MONTGOMERY COUNTY HISTORIC PRESERVATION COMMISSION
STAFF REPORT

Address:	20410 N. Frederick Rd., Germantown	Meeting Date:	4/5/2017
Resource:	Cider Barrell <i>Master Plan Site #19/33</i>	Report Date:	3/29/2017
Applicant:	Stringtown Investments, LLC (Brandi Edinger, Agent)	Public Notice:	3/22/2017
Review:	HAWP	Tax Credit:	Partial
Case Number:	19/33-17A	Staff:	Michael Kyne
PROPOSAL: Alterations to doors and windows and other alterations

STAFF RECOMMENDATION

Photo #1:

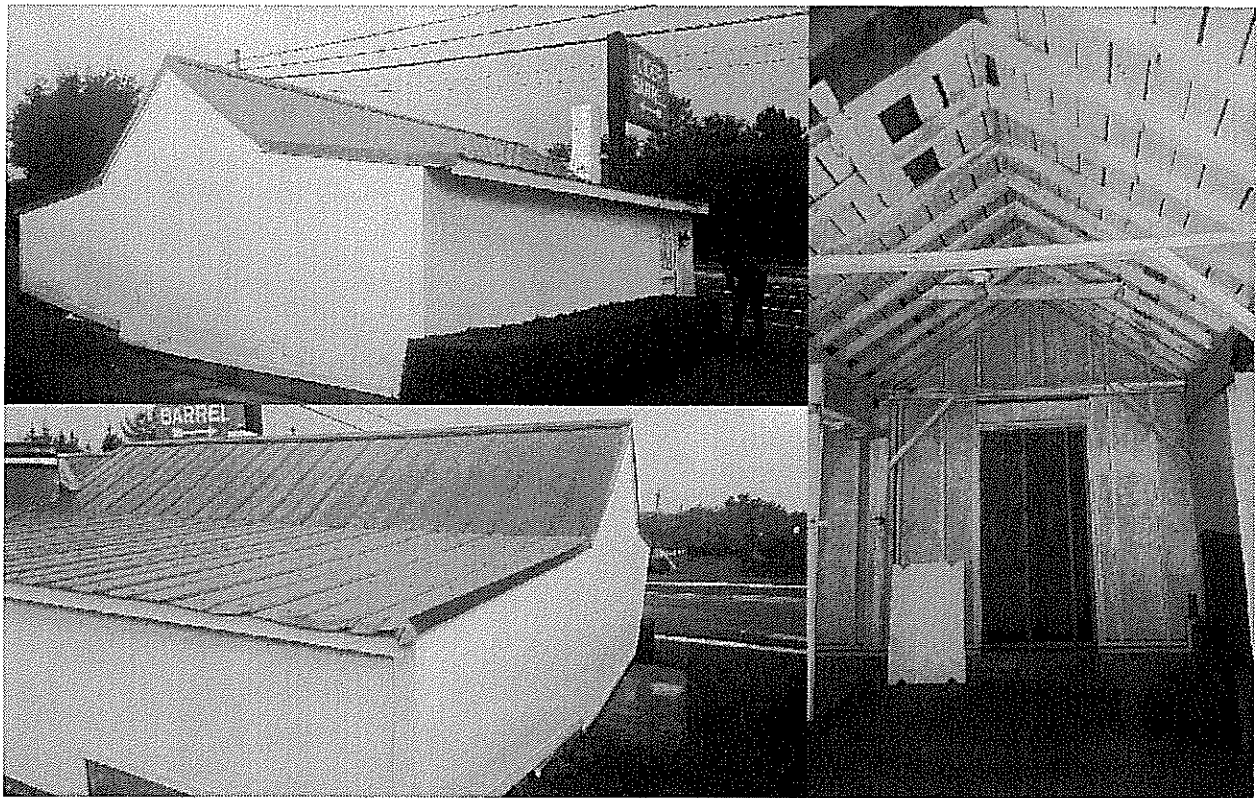
- In the submitted plans and elevations, a window opening is depicted on the rear elevation under the cross gable, and it is noted that a new window will be installed in this location. However, the captioned photographs state that the boarded-up opening is a door, and the interior photographs seem to support this. It states that a new half glass door will be installed in this location for utility purposes. The captioned photographs are dated March 17, 2017, whereas the plans and elevations are dated to January 1, 2017, which leads staff to believe that the photographs accurately reflect the current proposal.

Staff is supportive of either a new window or door in this location, as the location has clearly been boarded-up. Although the interior photographs suggest that a door was in this location, either a door or window would be appropriate, as neither would require the removal of historic materials. The proposed alteration is on the rear elevation, where it is not visible from the public right-of-way of Frederick Road, and, in accordance with the *Standards*, will not remove features that characterize the property.

1. Details will be submitted for all proposed windows and doors, with final review and approval delegated to staff.
2. The proposed soffits will be wood with aluminum vents.
3. Material specifications will be submitted for the proposed through-the-wall exhaust fan.
